WHITEFISH **CITY HALL AND PARKING STRUCTURE**

Whitefish City Hall Design Review Summary

December 4, 2014

Main Floor

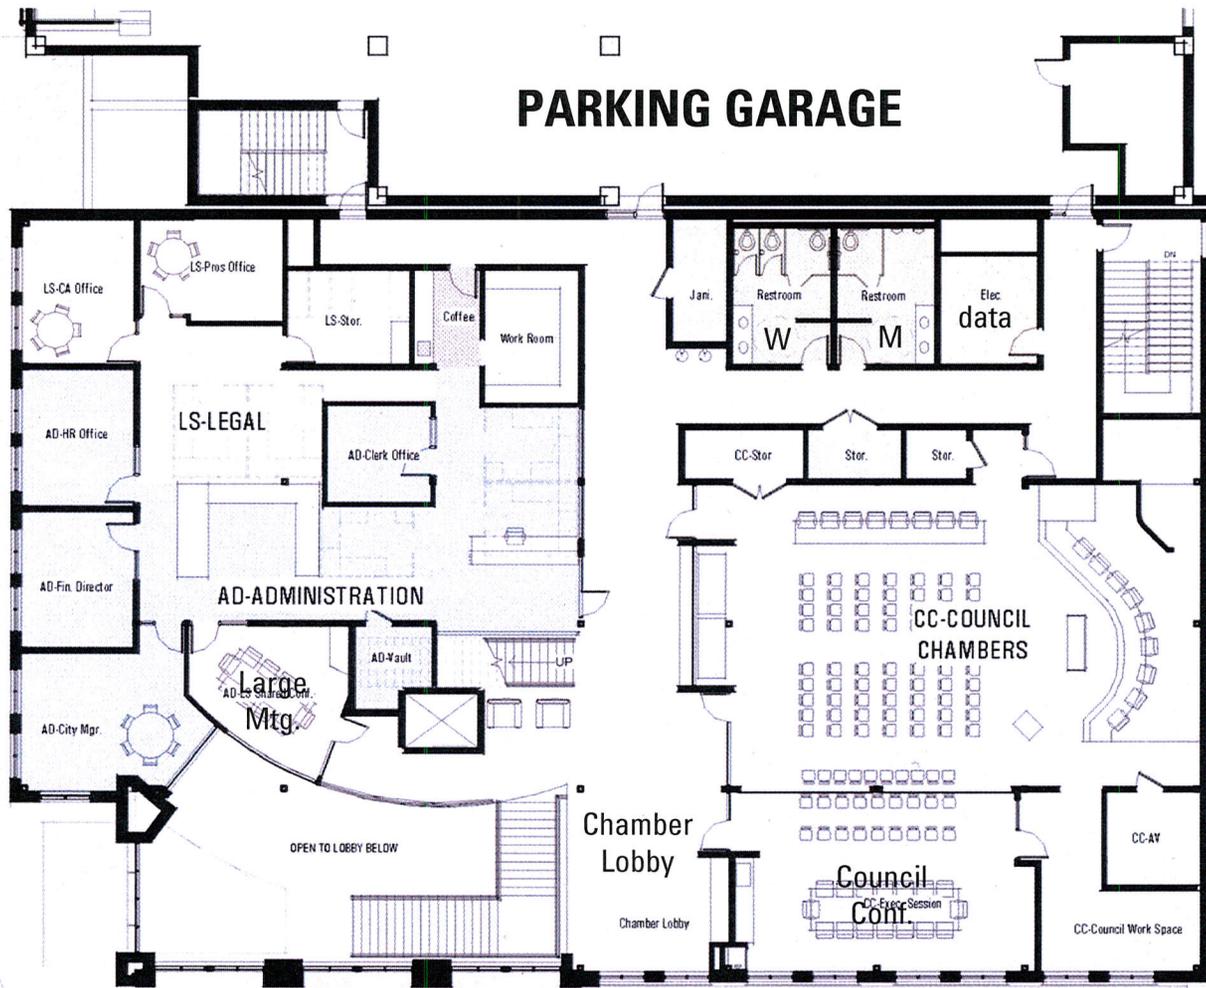
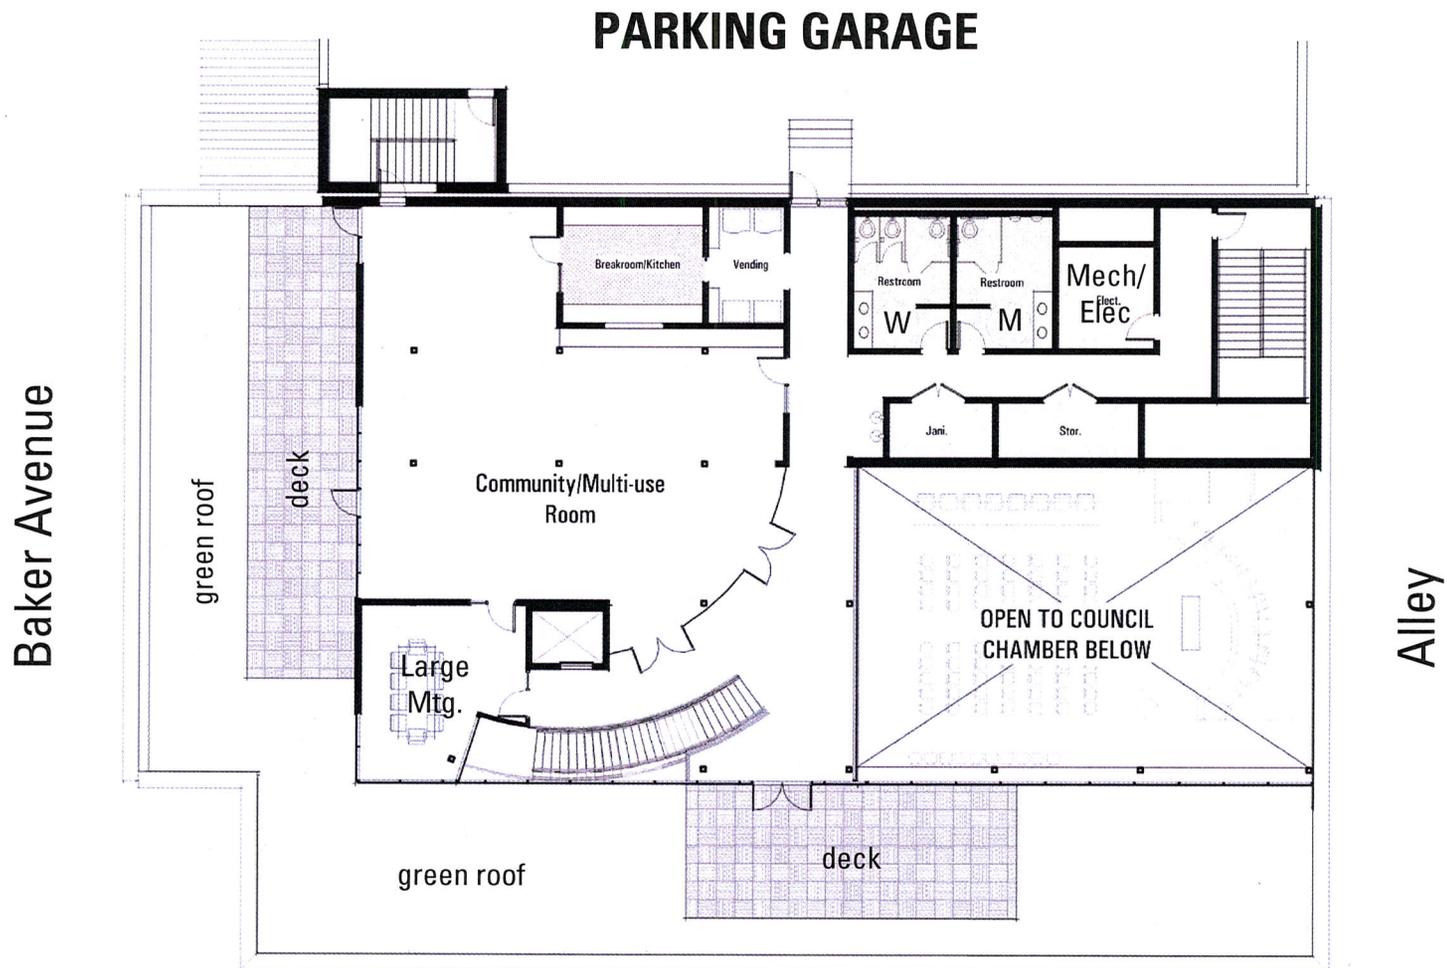
Building Lobby – The lobby is not generous in size with space for visitor seating or displays. The stairway crowds the lobby space.

Recommendation #2 – Develop a plan alternative that relocates the stair.

Building Entry – Two existing buildings on the Baker/Second Street intersection have diagonal corner entries . A City Hall corner entry would play off of the established urban design theme and make the intersection unique and special.

Recommendation #3 – Develop a plan alternative that provides a entry on the diagonal.

West Elevation – City Hall

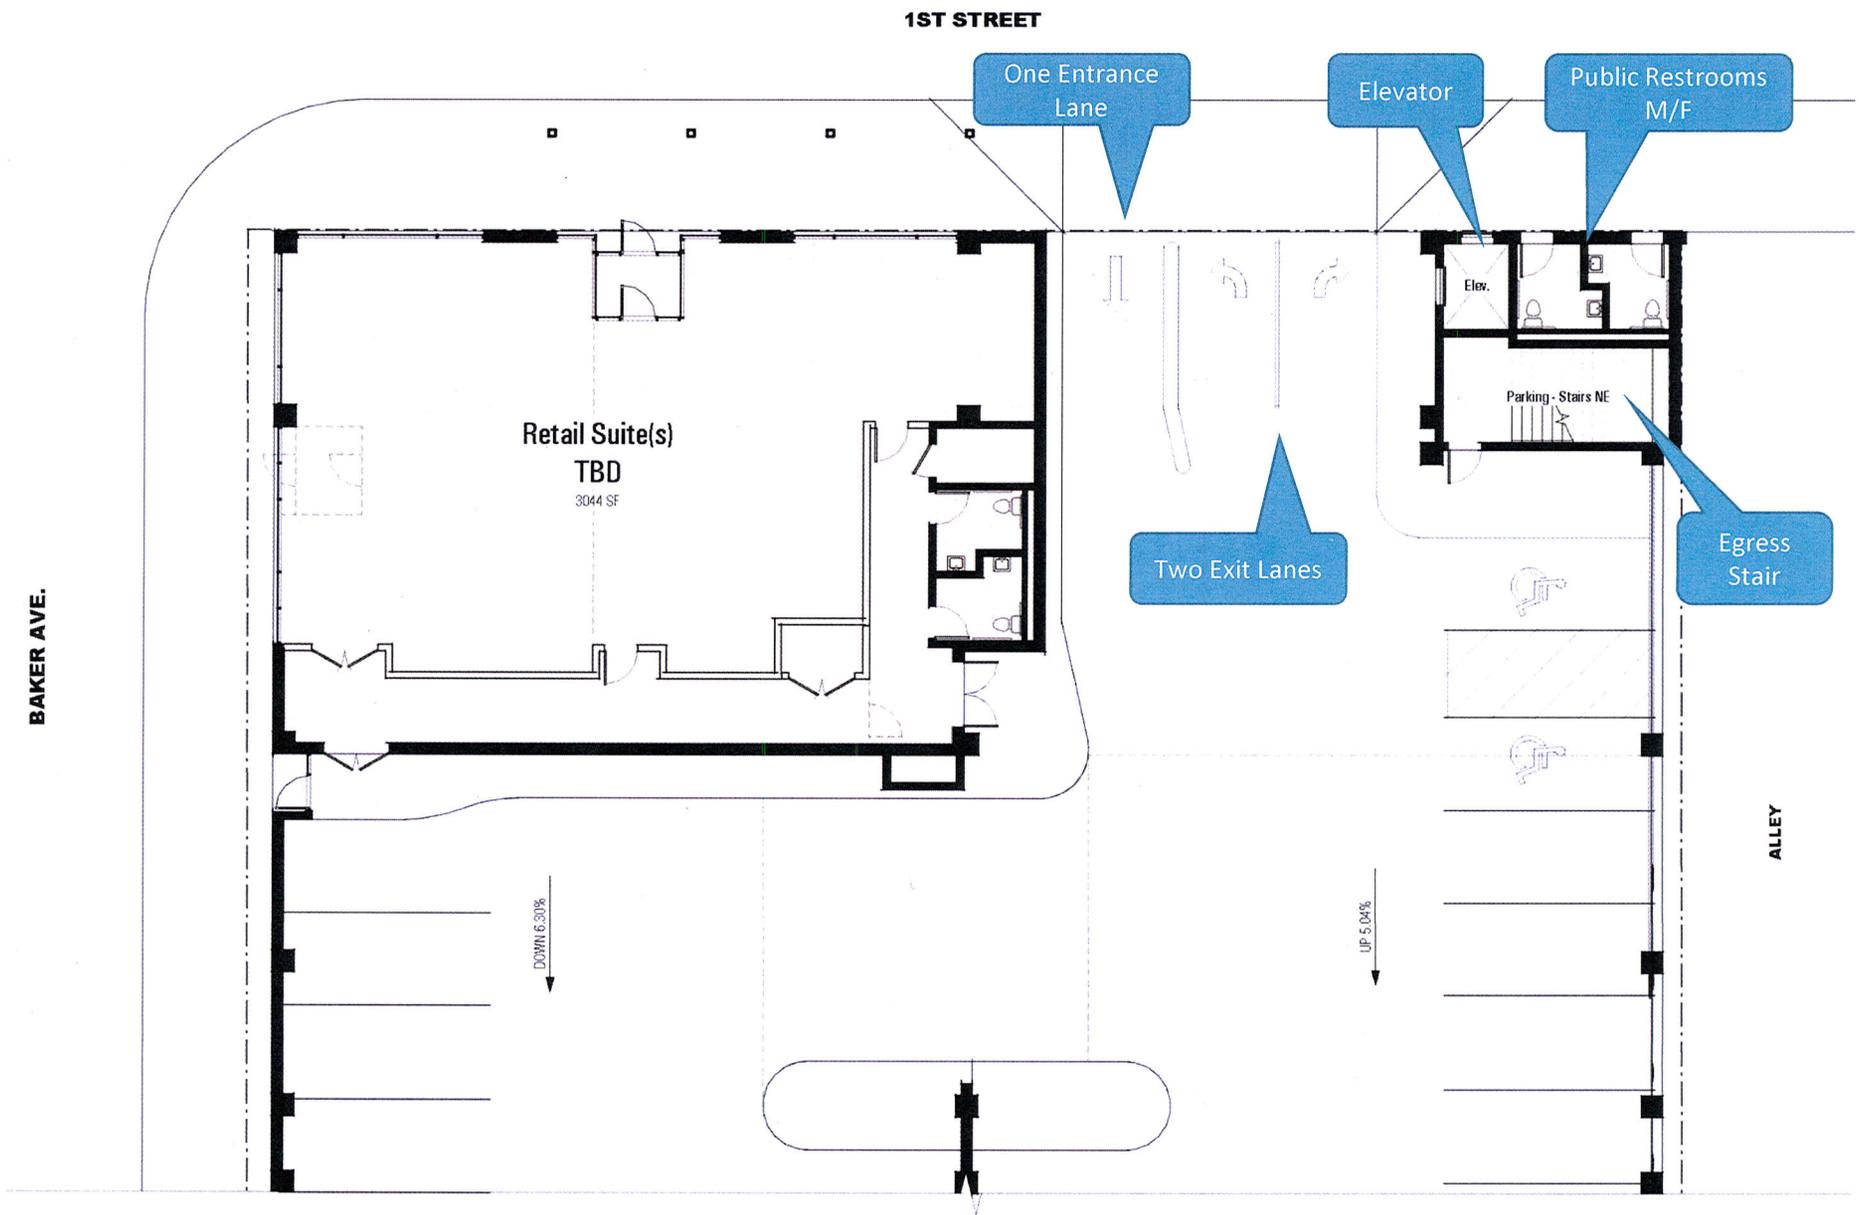
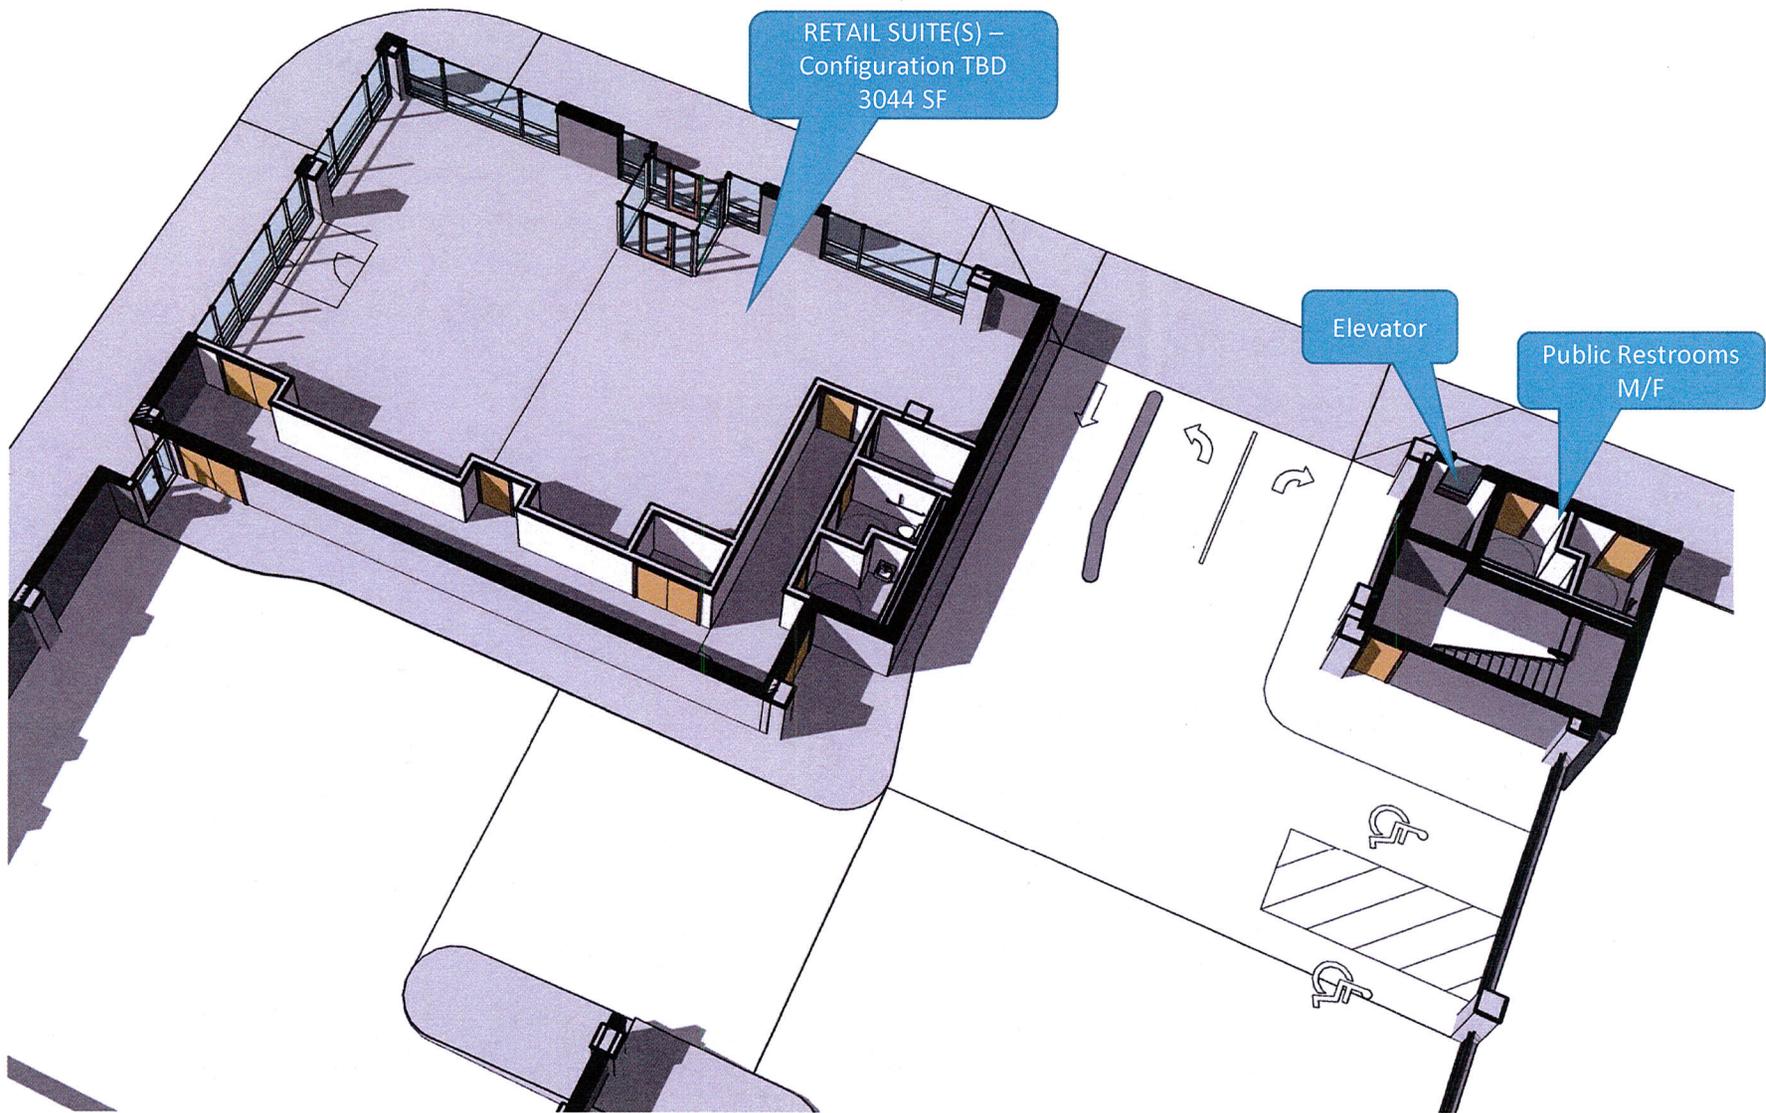
Historic Context - The community has stated that they want a building that fits into the Whitefish historic context. The architects have stated that they understand this requirement.

Recommendation #1 - Remove contemporary design features from building facades.
